## BOULDER COUNTY BOARD OF COUNTY COMMISSIONERS PUBLIC HEARING

#### **Docket LU-24-0001: BCPOS Sherwood Creek Restoration**

Proposal: Limited Impact Special Use Review to permit 8,843 cubic yards of non-foundational earthwork for restoration of the Sherwood Creek stream channel

DRAWING NUMBER:  
**D-1**  
SHEET 14

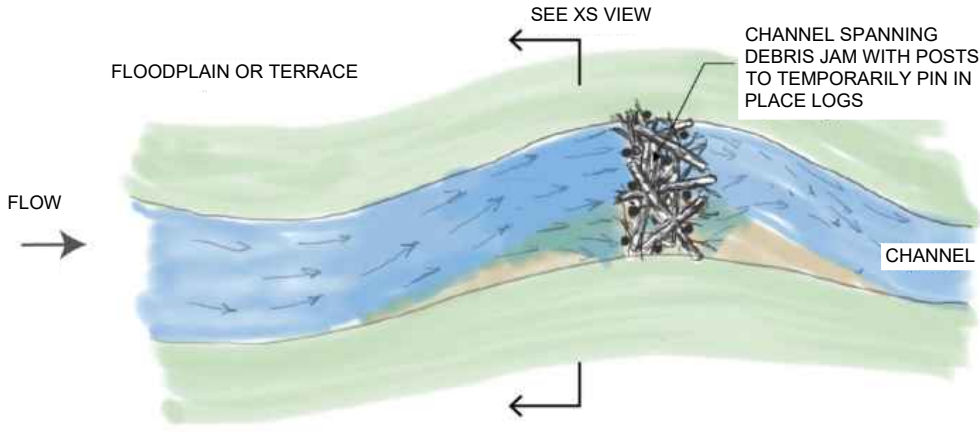
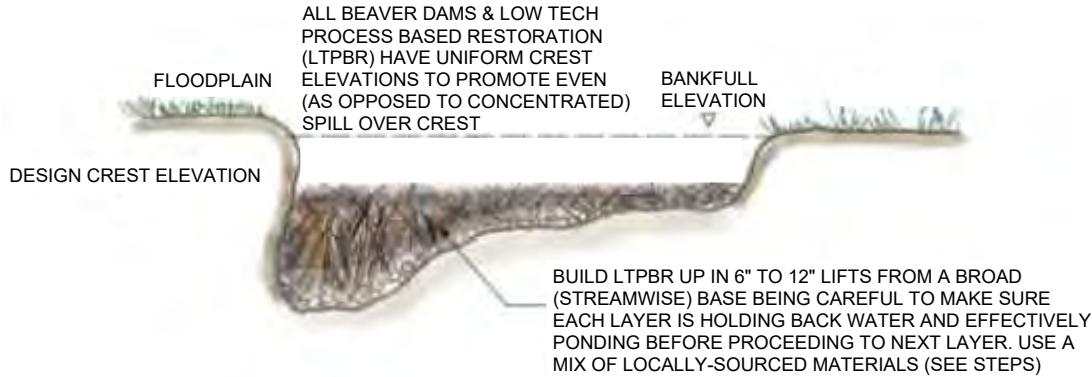
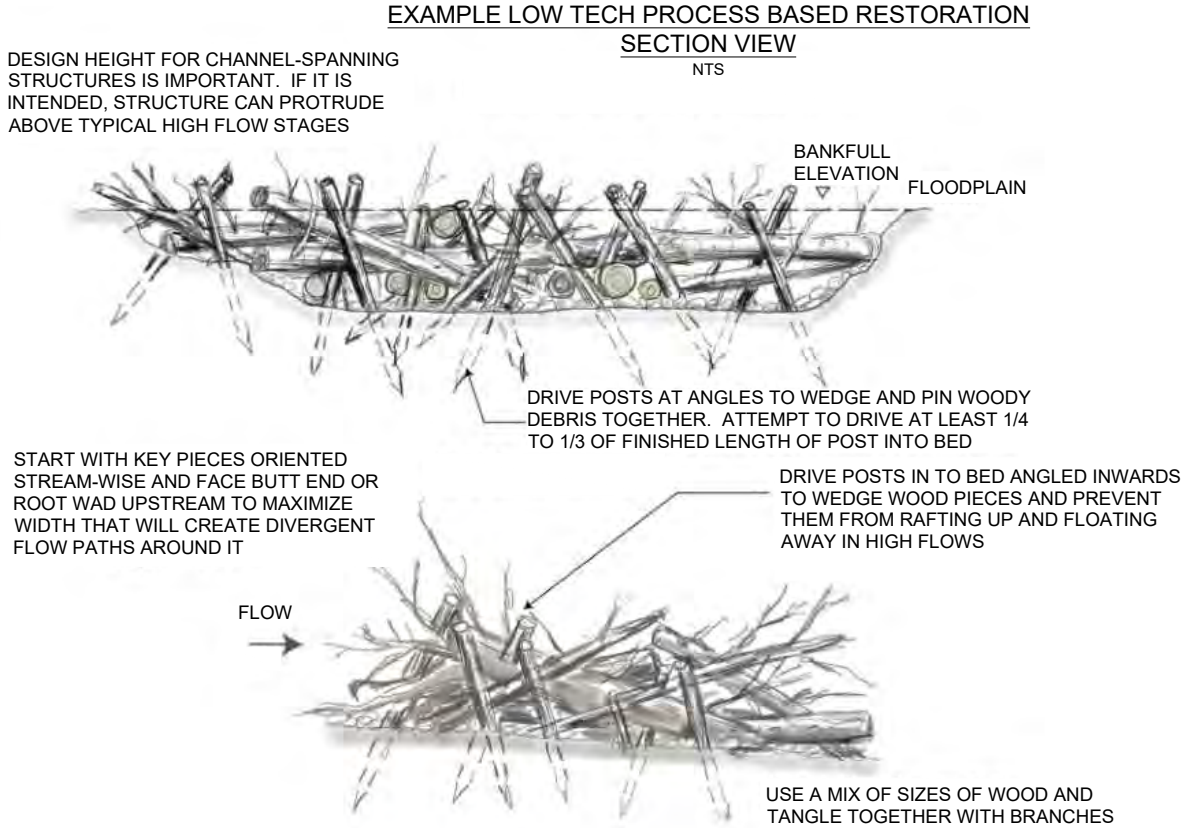
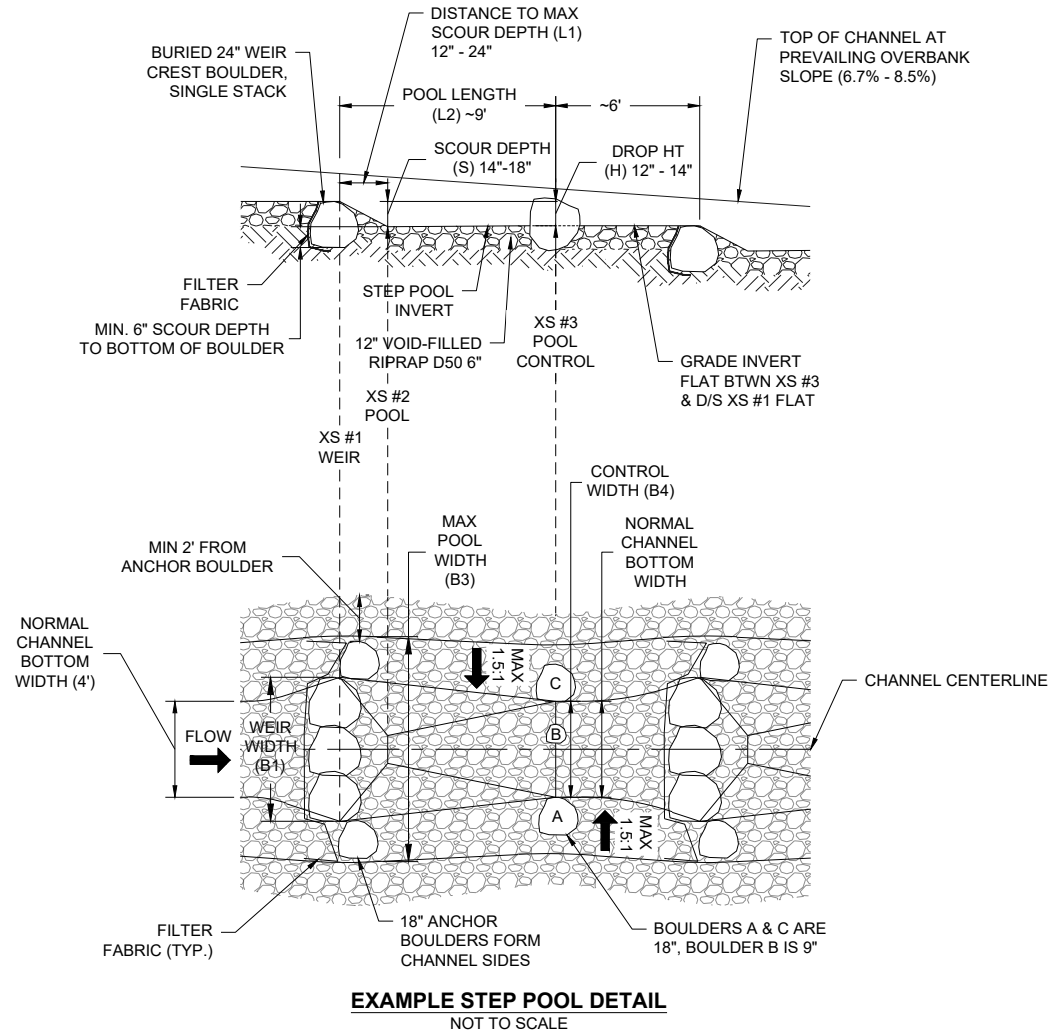
Sheet D-1 – Staff notes that which of the two structure designs would be used will occur later, subject to the new law.

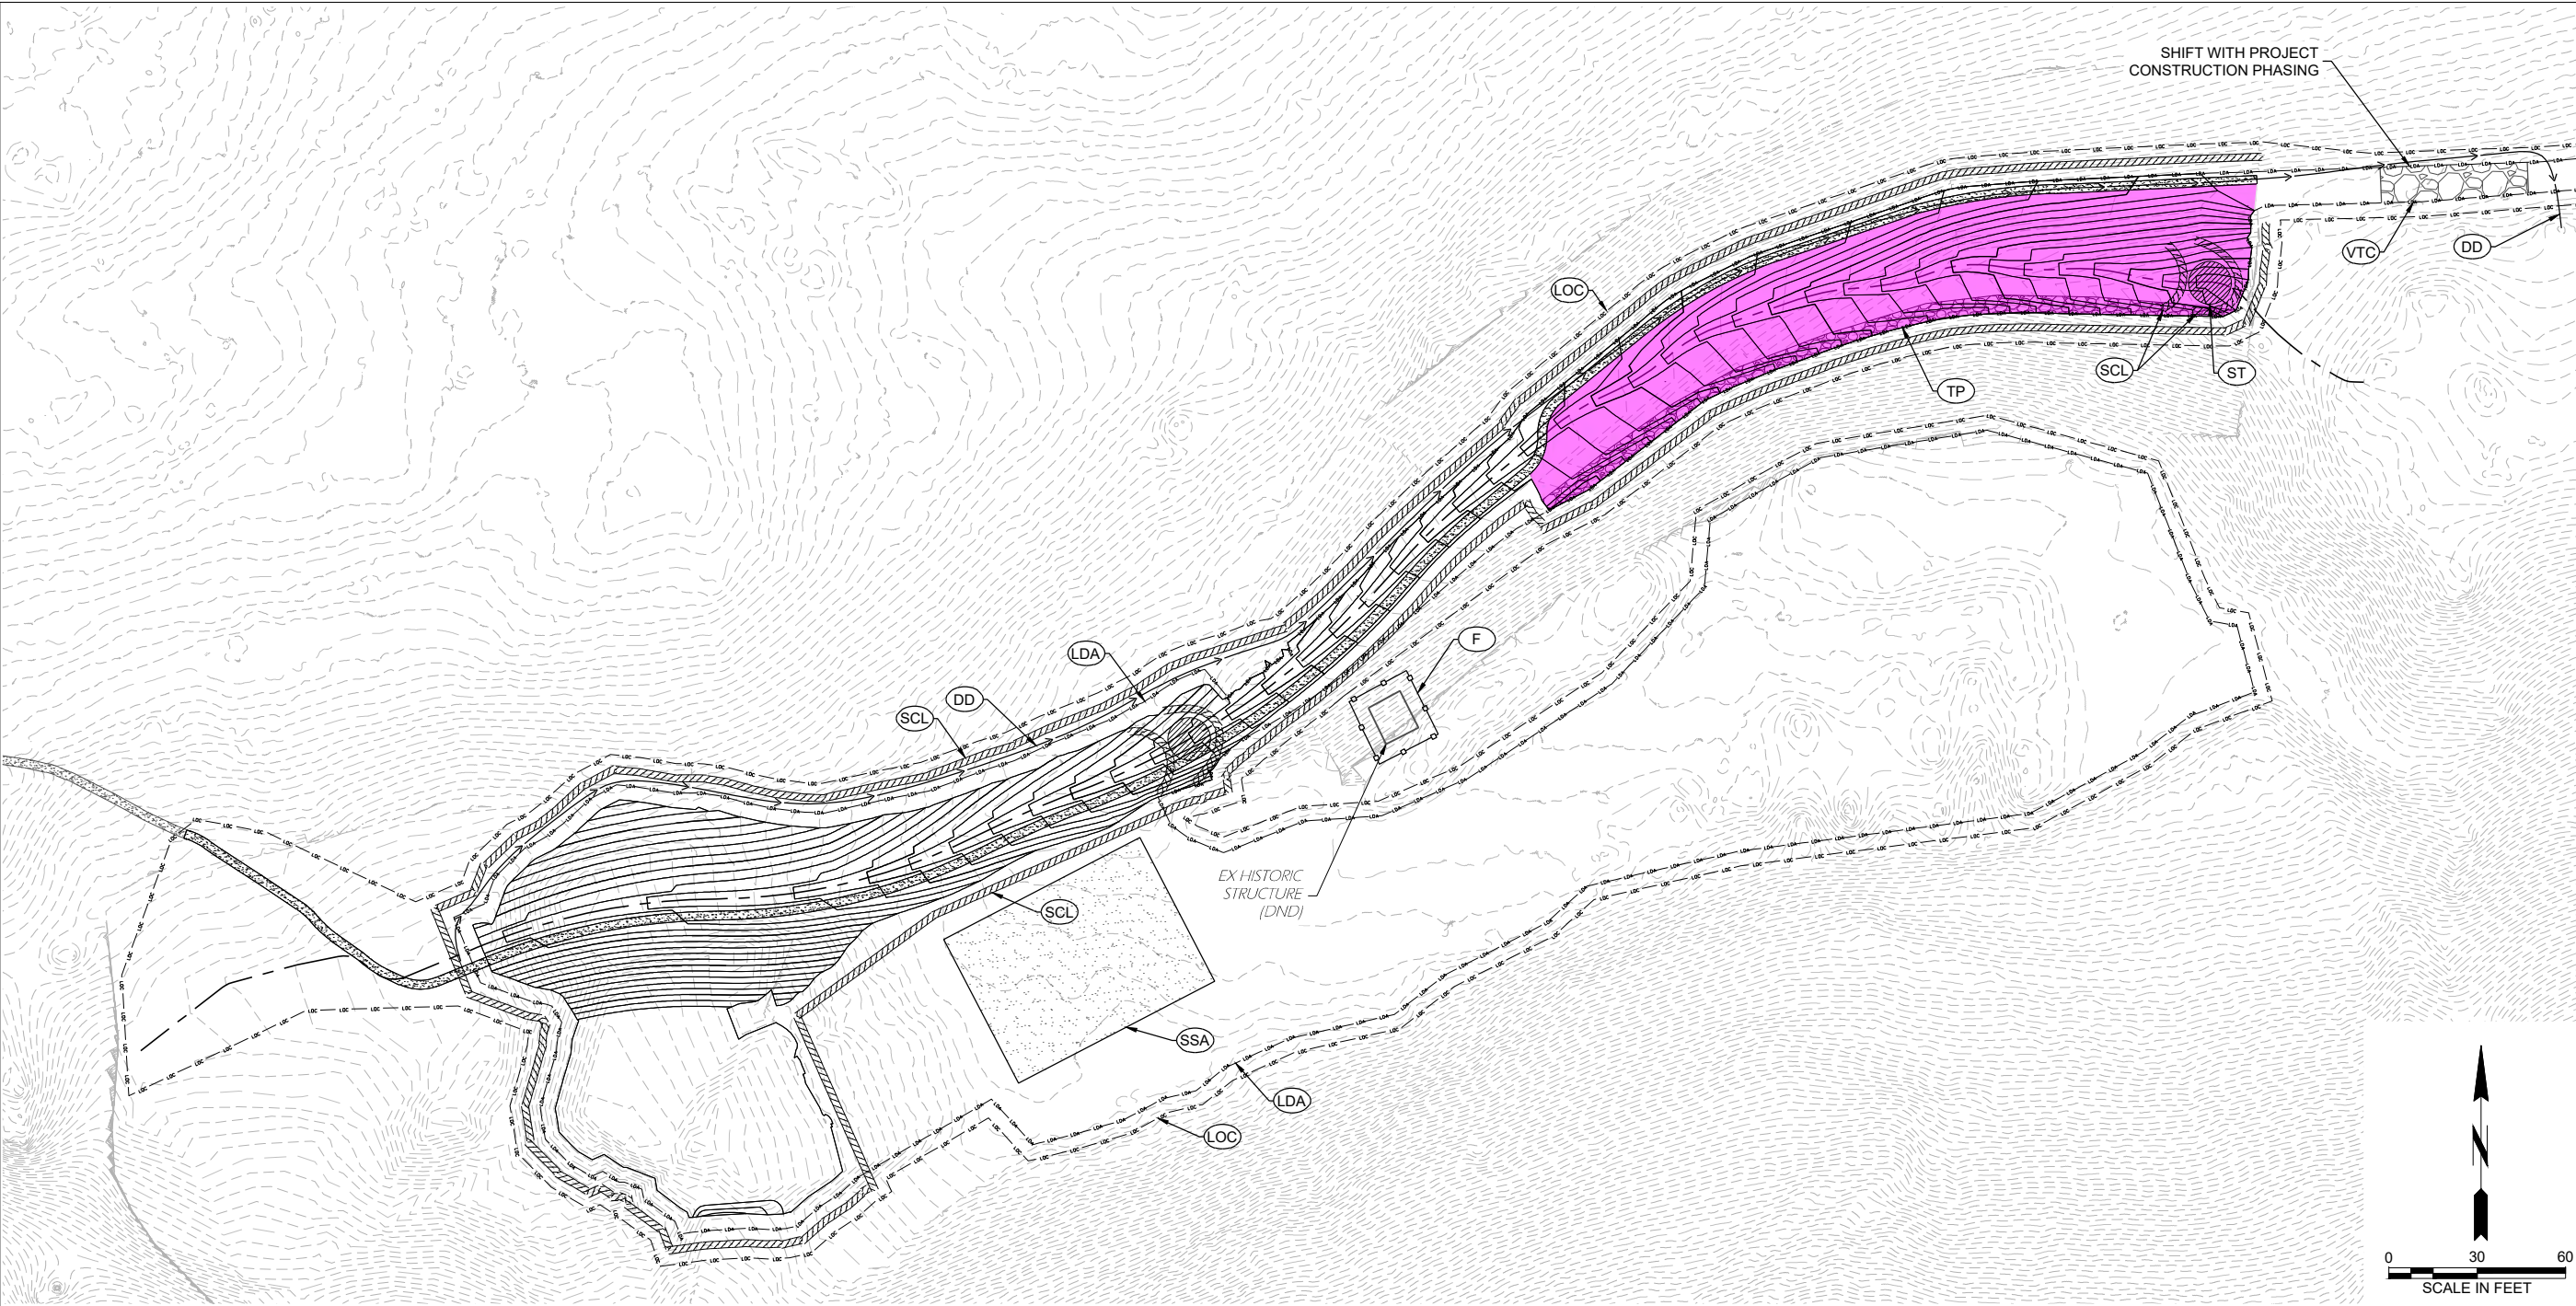
4. The proposed vehicle tracking control (VTC) located downstream of existing seeps (Shown on Sheet 17, Drawing Number S-1 dated 01/08/2024) does not demonstrate connection to the stabilized staging areas (SSA).

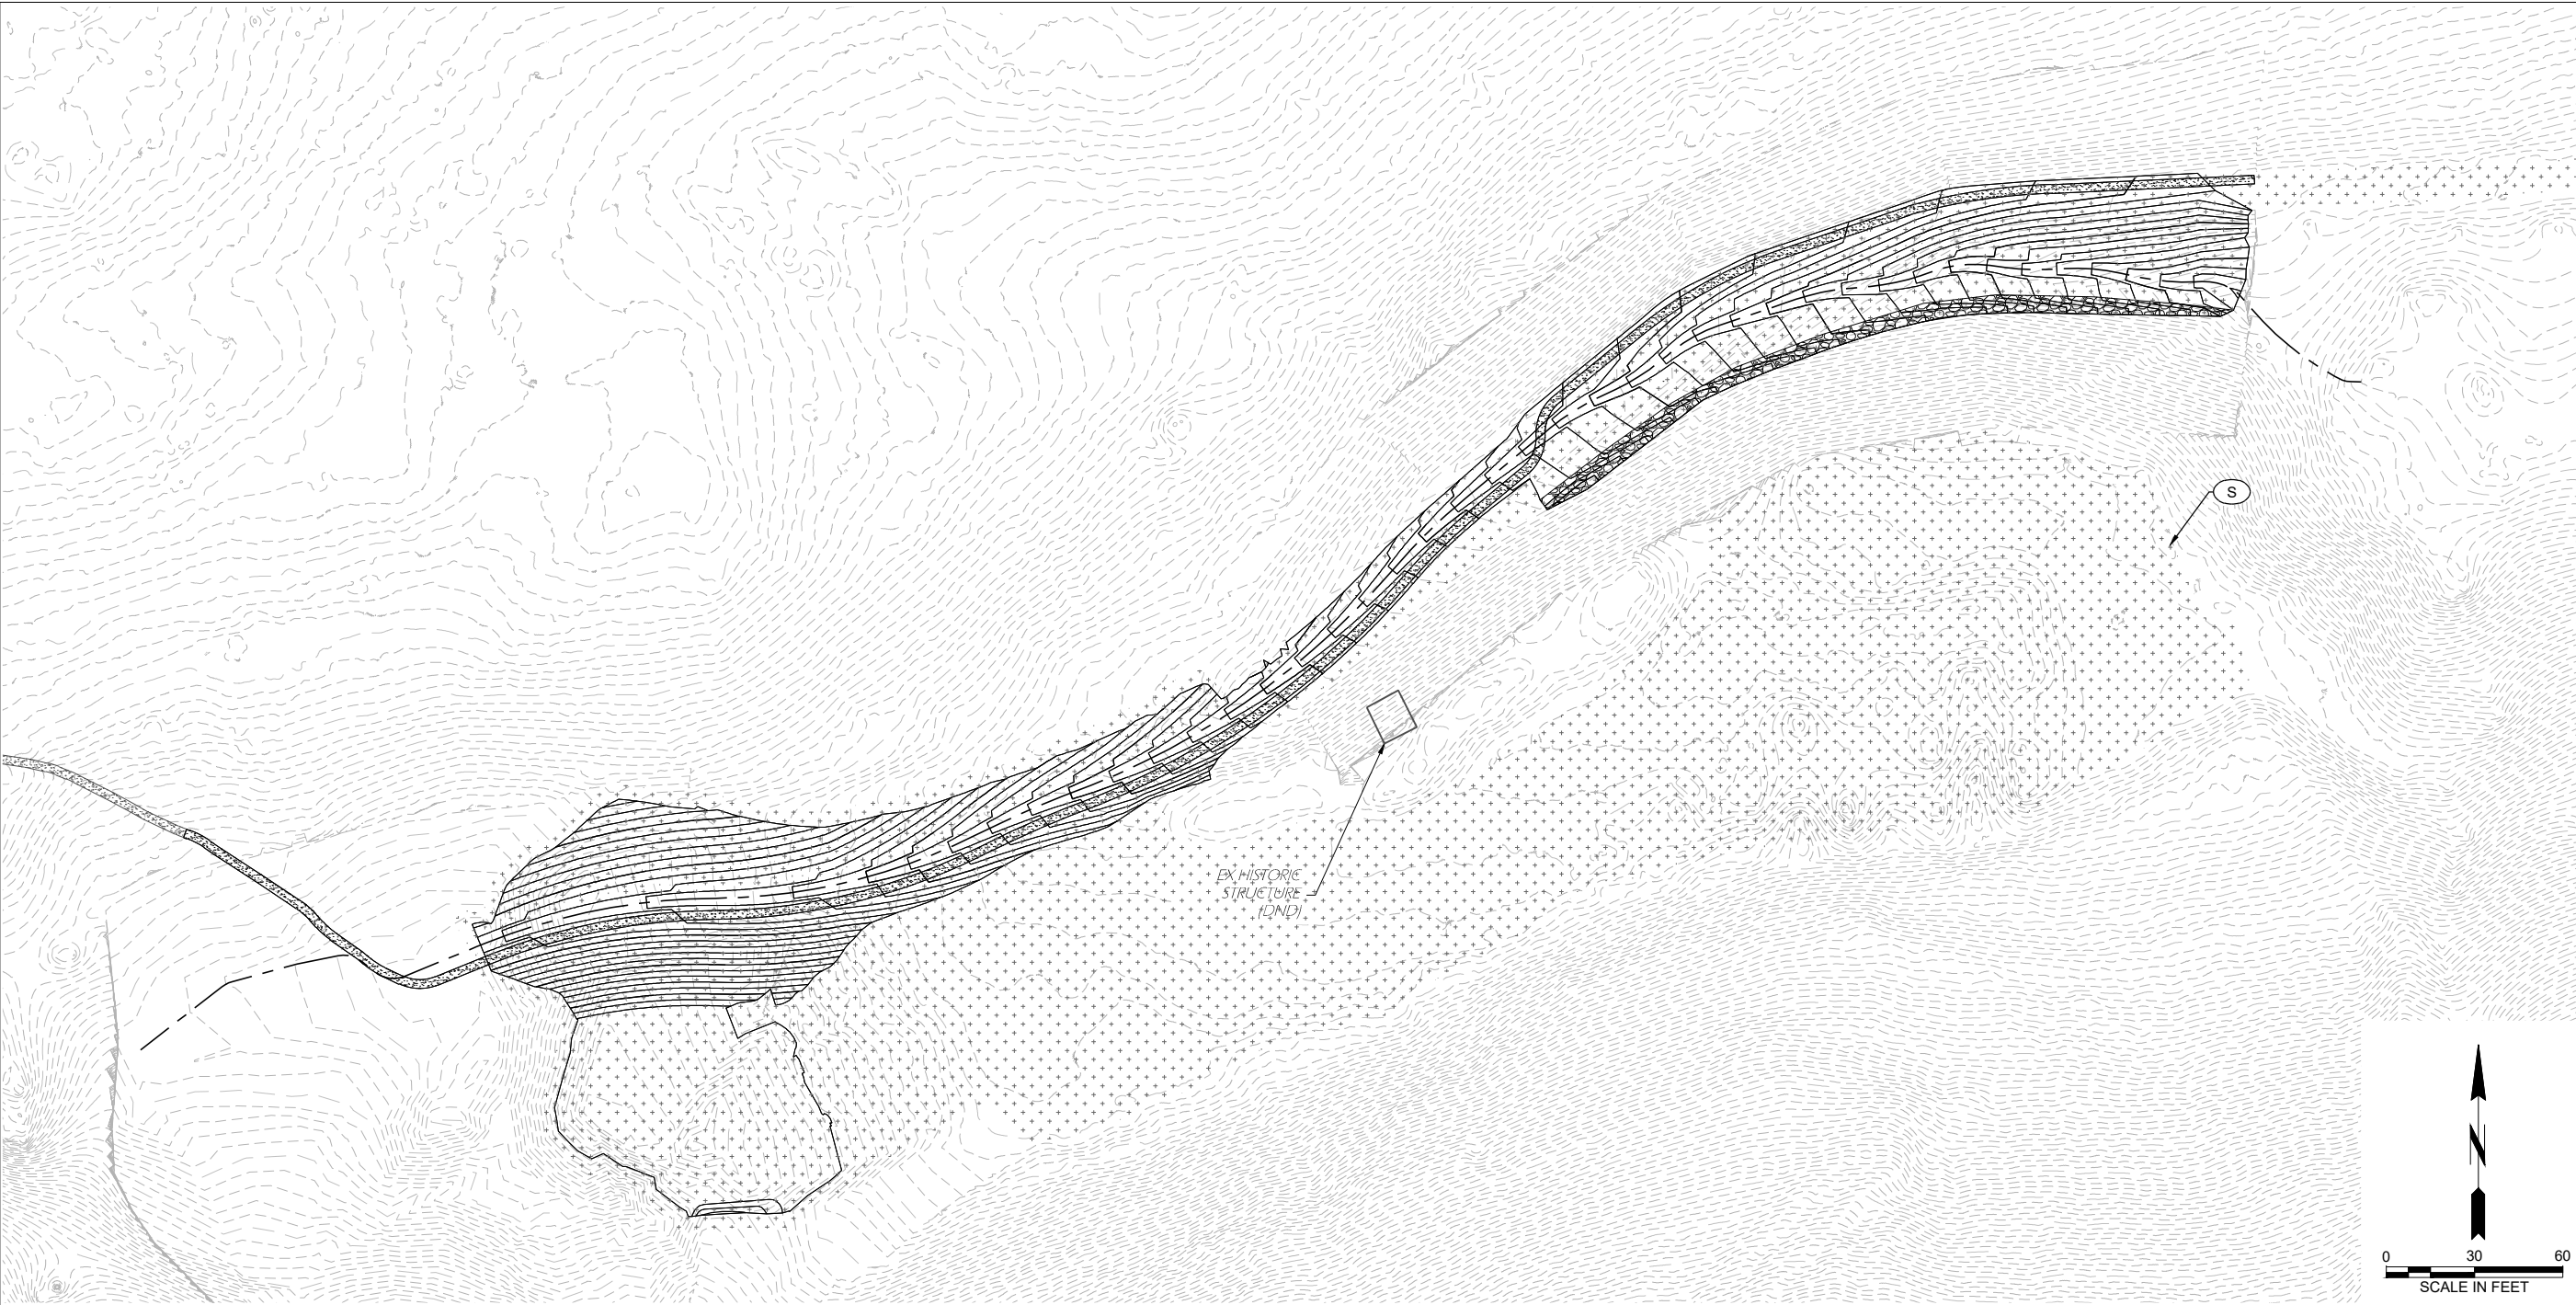
Sheet S-1 and S-2 – Much of the sediment control logs shown on these drawings are on uphill gradients to the construction areas, and are not necessary. This appears to be the case on the western and northern sides. If these are to demarcate the extent of disturbance/equipment use, construction fencing should be used instead.

S-5  
SHEET 20

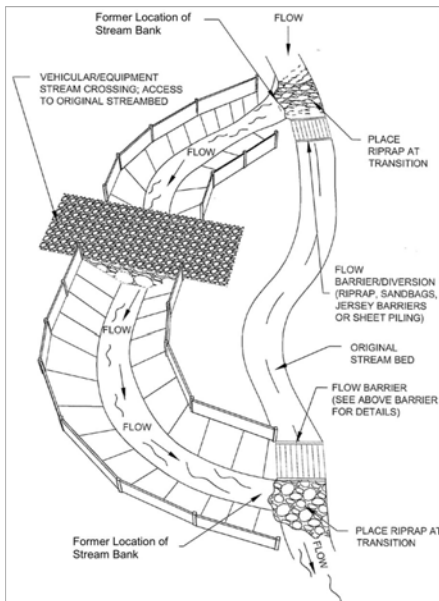
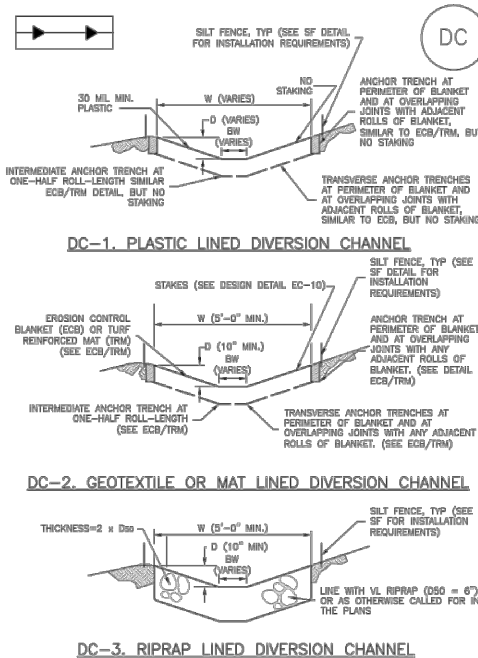
Note 2 mentions “diversion,” yet the stream should not be running during construction. Sheet S-5 shows diversion details – SM-8.
